PROJECT OWNER : CK CAPITAL, LLC
PROJECT DESCRIPTION : CLEVELAND BROTHERS-MILESBURG
PROJECT ADDRESS : 4025N. EAGLE VALLEY ROAD, HOWARD, PA 16841
CONTRACTOR : KINSLEY CONSTRUCTION, INC.

DWG DESCRIPTION : GUARDRAIL & LADDER PLAN

SK#19
12-09-2025

1 SE701 ELEVATION VIEW

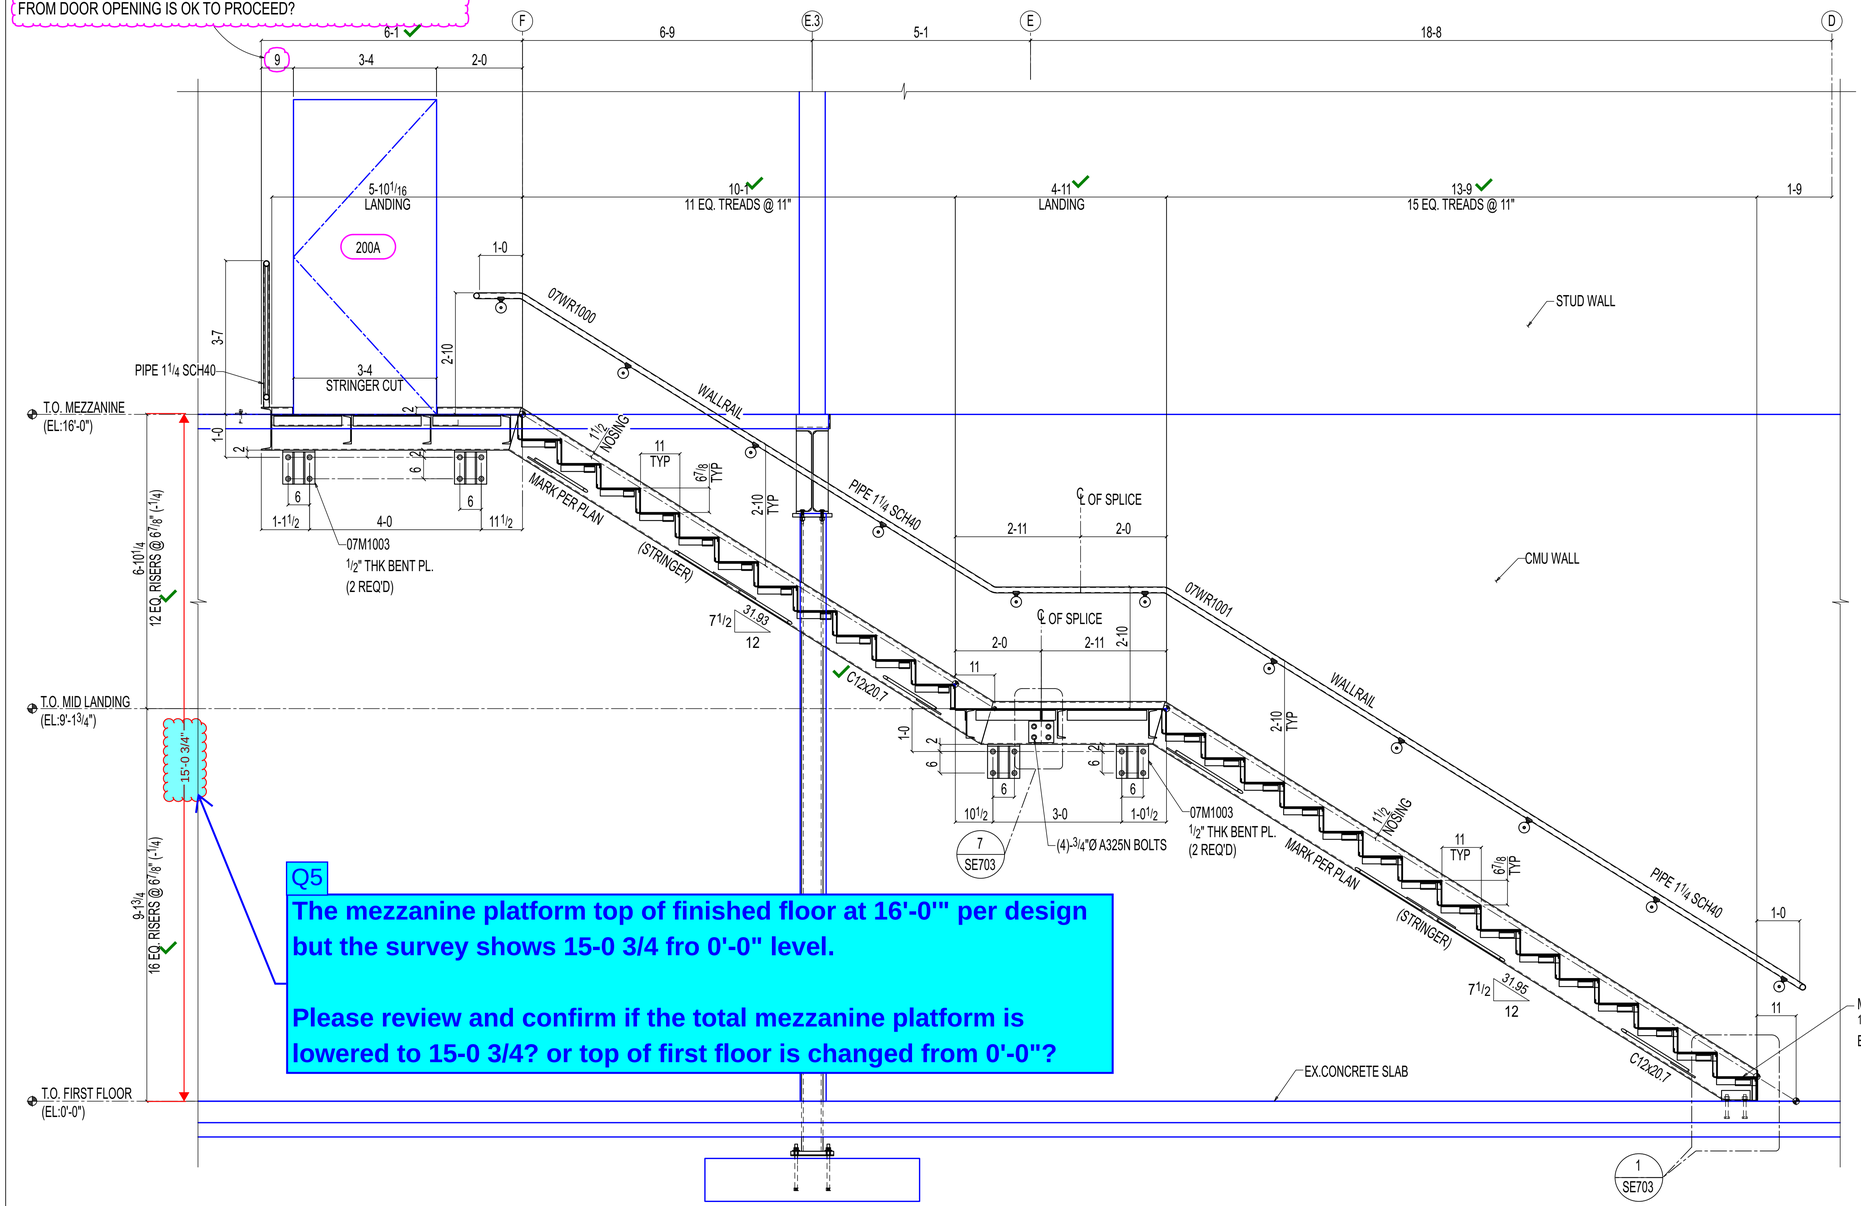
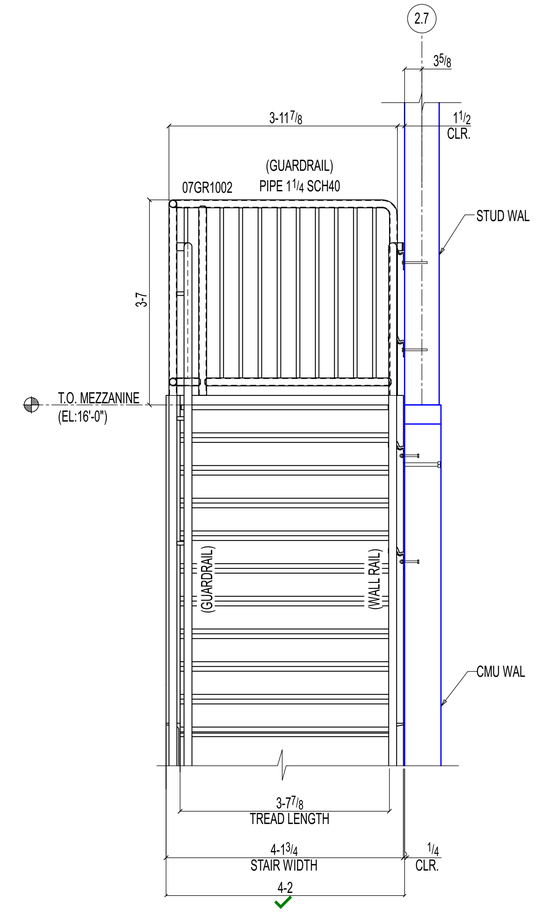
The mezzanine platform top of finished floor at 16'-0'" per design but the survey shows 15-0 3/4 fro 0'-0" level.

Please review and confirm if the total mezzanine platform is lowered to 15-0 3/4? or top of first floor is changed from 0'-0"?

2 SE711 ELEVATION VIEW

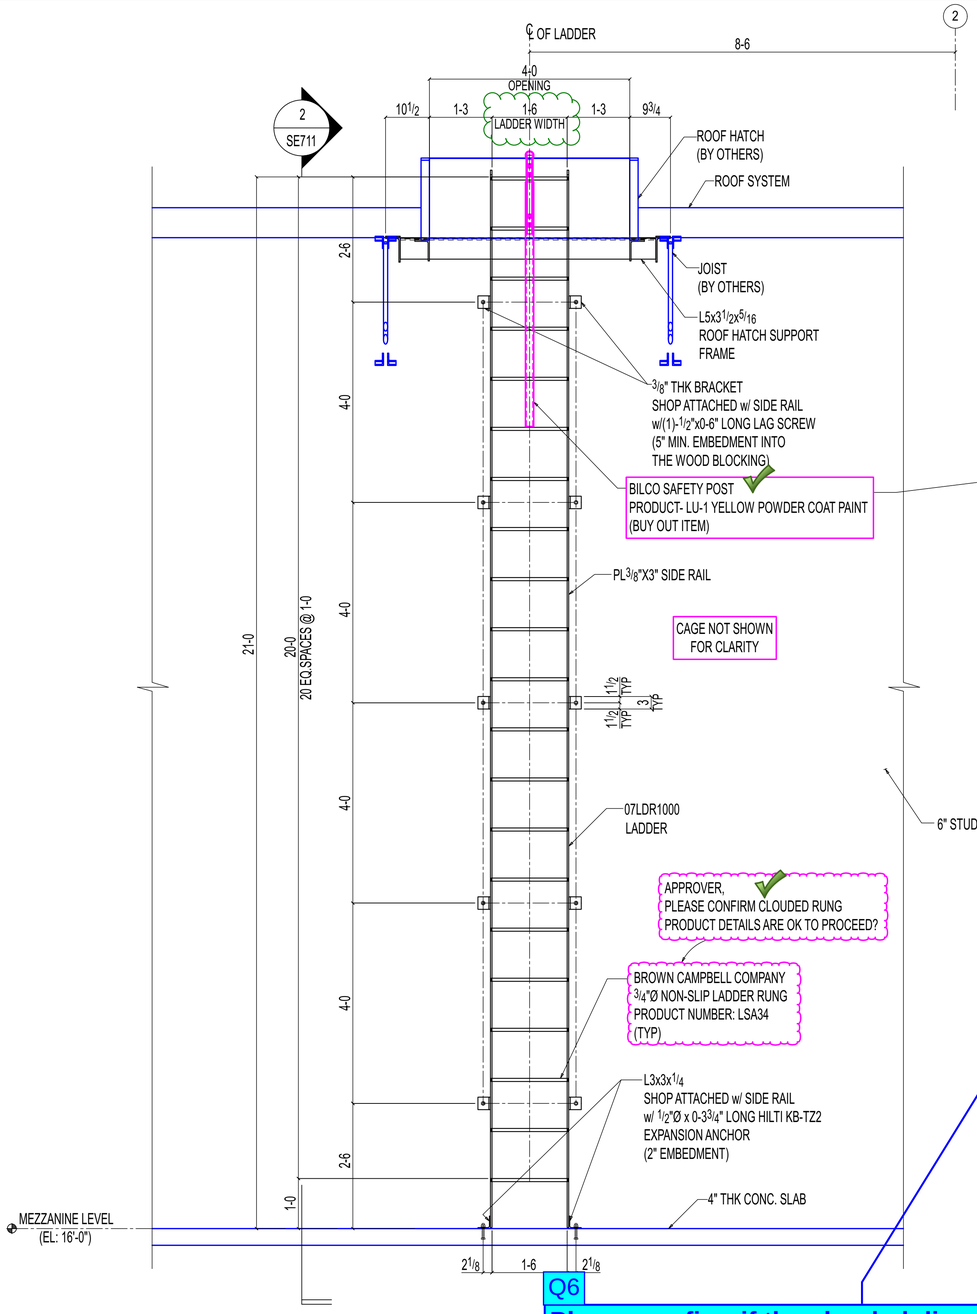
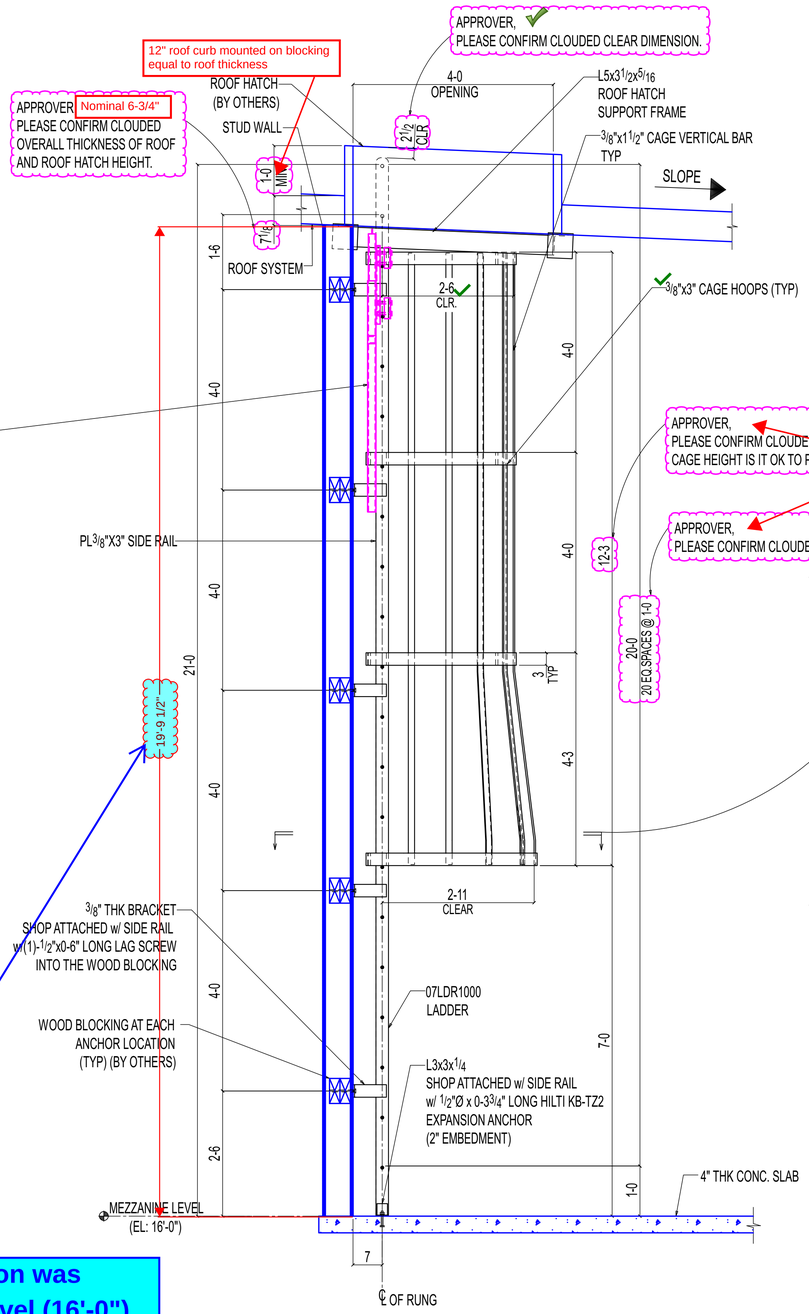
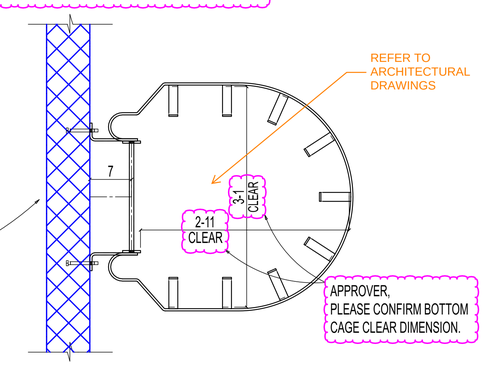
Please confirm if the clouded dimension was taken from the top of the mezzanine level (16'-0") since per the previous question Q5, it seems mezzanine finished floor may changed 15-0 3/4 from 16-0.

THIS ELEVATION IS INCORRECT, REFER TO STR. DRAWINGS.

1 SE708 ELEVATION VIEW

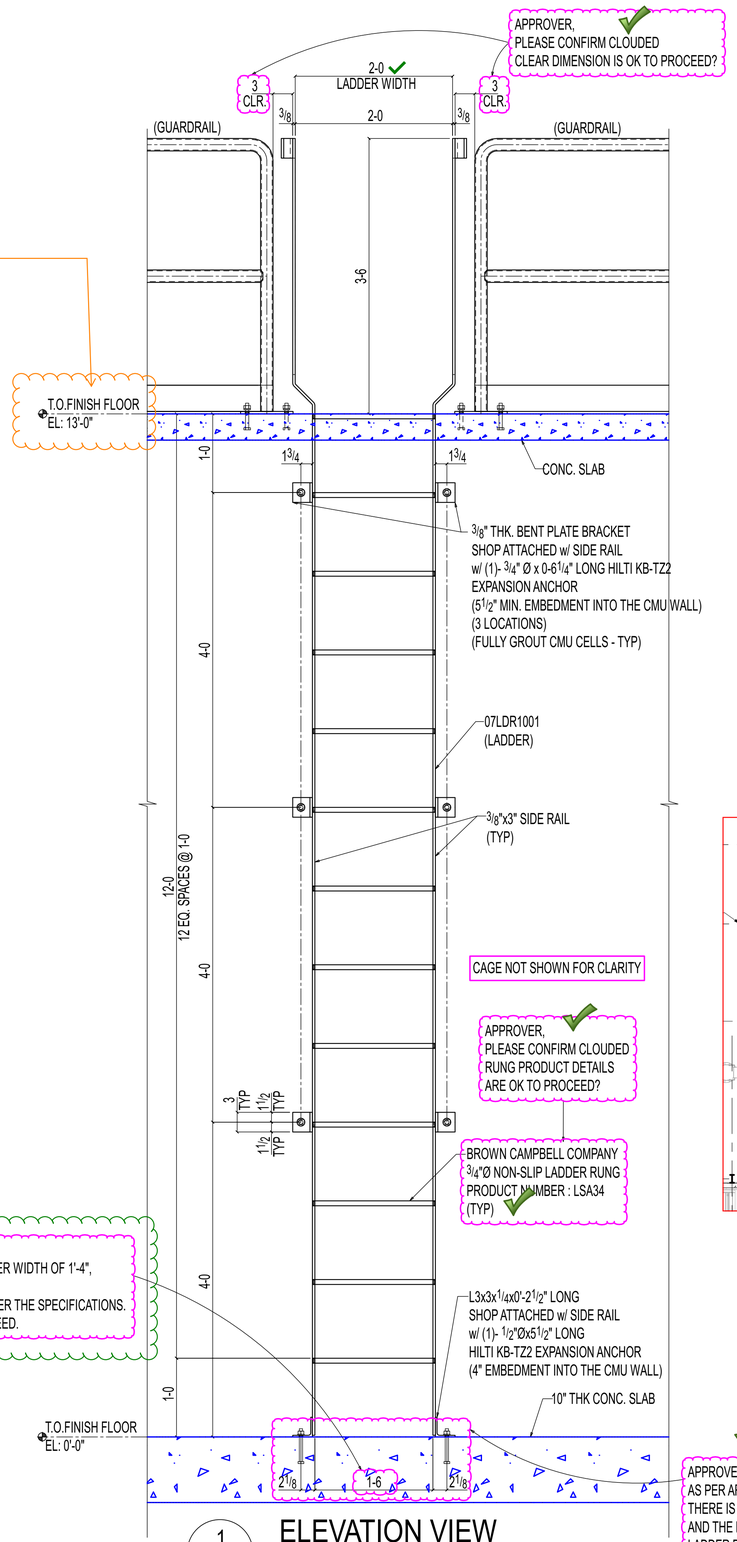
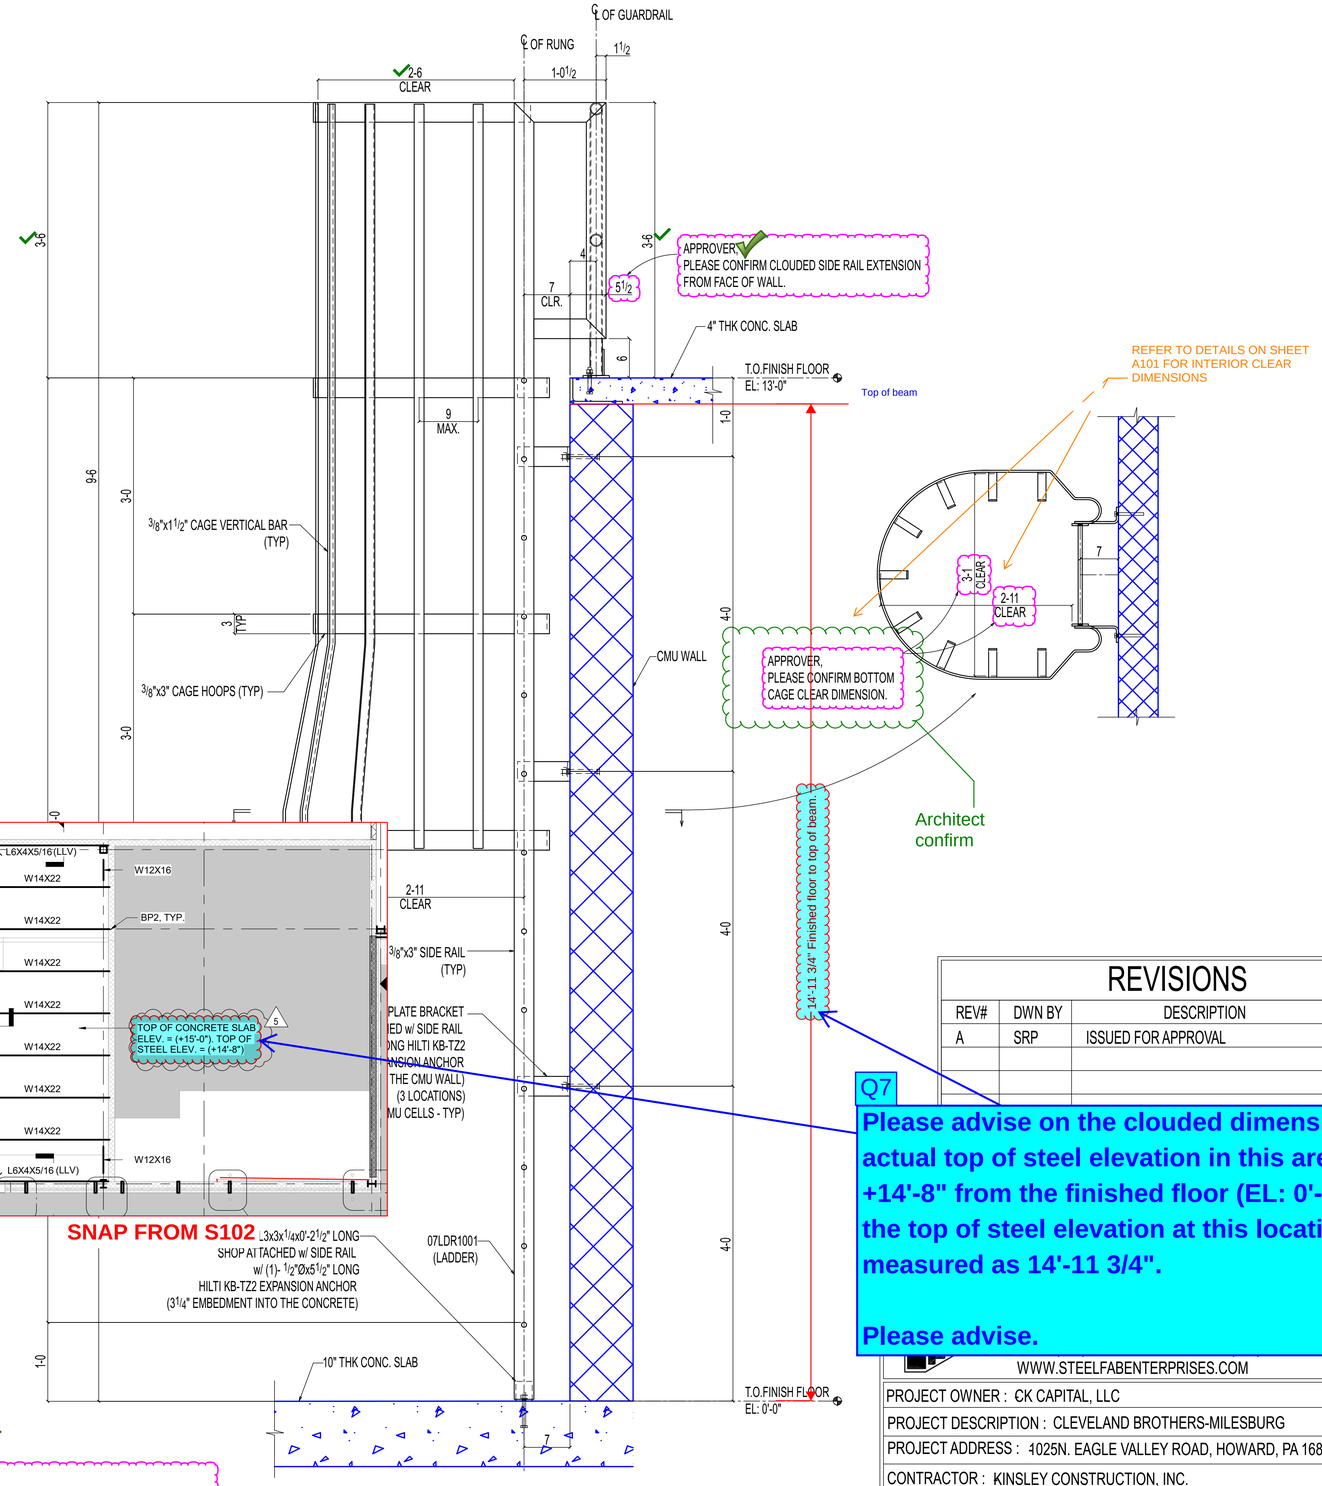
APPROVER, AS PER ARCHITECTURAL DRAWING 6/A101, THERE IS A CLEARANCE BETWEEN THE FLOOR AND THE LADDER. WE INTEND TO CONNECT THE LADDER DIRECTLY TO THE FLOOR INSTEAD. PLEASE CONFIRM IF THIS IS ACCEPTABLE TO PROCEED.

Please advise on the clouded dimension. The actual top of steel elevation in this area is +14'-8" from the finished floor (EL: 0'-0"), but the top of steel elevation at this location measured as 14'-11 3/4".
